DESCRIPTION/DESCRIZIONE
SOSTITUZIONE MOTORE VENTILAZIONE LILLIPUT 15
REPLACEMENT VENTILATION MOTOR LILLIPUT 15

DRAFTED/DISEGNATO	DATE/DATA	SCALE/SCALA	CODE/CODICE	SHEET/FOGLIO	APPROVED/APPROVATO	DATE/DATA
Soave	30/07/2020	- -	IMPI0197	1/1	Farina Simone	30/07/2020

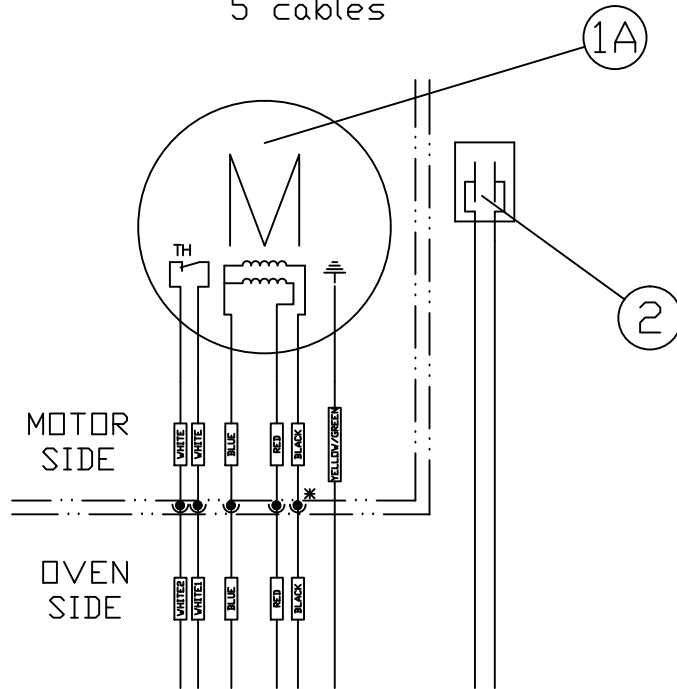
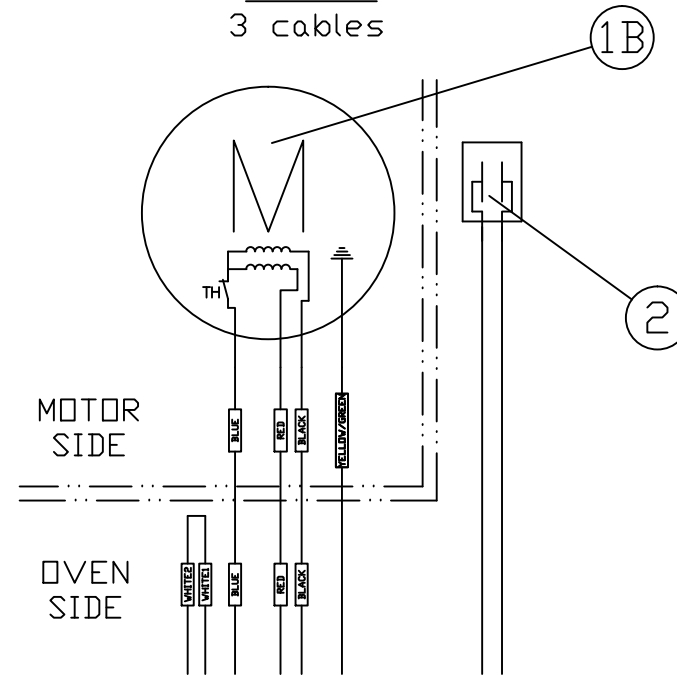
Old electric motor,
with thermal sensor
5 cables

New electric motor,
with thermal sensor
inside
3 cables

* REMOVE THE
TERMINAL PLUG

CHECK THE ROTATION OF THE MOTOR.
ALL THE MOTORS IN THE OVEN MUST
TURN SAME SIDE.
